**REPORT OF THE WORKING PARTY ON POLLUTION AND ENERGY
ON ITS FIFTY-SIXTH SESSION
(Geneva, 3 – 6 June 2008)**

ADOPTED AMENDMENTS TO ECE/TRANS/WP.29/GRPE/2008/6
(Regulation No. 83, see paragraph 26 of this report)

Page 4, Annex 4, paragraph 6.1.3., correct to read:

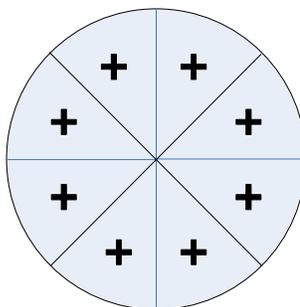
The above mentioned air velocity shall be determined as an averaged value **of a number of** measuring points which:

- (a) **for blowers with rectangular outlets** are located at the centre of each rectangle dividing the whole of the blower outlet into 9 areas (dividing both horizontal and vertical sides of the blower outlet into 3 equal parts).
- (b) **for circular blower outlets, the outlet shall be divided into 8 equal arcs by vertical, horizontal and 45° lines. The measurement points lie on the radial centre line of each arc (22.5°) at a radius of two thirds of the total (as shown in the diagram below).**

Each value at **those points** shall be within 10 per cent of the averaged value of themselves.

Page 6, Annex 4a, paragraph 3.4.2., correct to read:

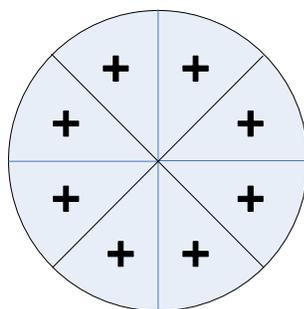
"3.4.2. A current of air within ± 5 km/h of the corresponding roller speed **within the range of 10 km/h to 50 km/h. At the range over 50 km/h, the linear velocity of the air shall be within ± 10 km/h of the corresponding roller speed. At roller speeds of less than 10 km/h, air velocity may be zero.**

The above mentioned air velocity shall be determined as an averaged value of a number of measuring points which:

- (a) for blowers with rectangular outlets are located at the centre of each rectangle dividing the whole of the blower outlet into 9 areas (dividing both horizontal and vertical sides of the blower outlet into 3 equal parts).**
- (b) for circular blower outlets, the outlet shall be divided into 8 equal arcs by vertical, horizontal and 45° lines. The measurement points lie on the radial centre line of each arc (22.5°) at a radius of two thirds of the total (as shown in the diagram below).**

Each value at those points shall be within 10 per cent of the averaged value of themselves.
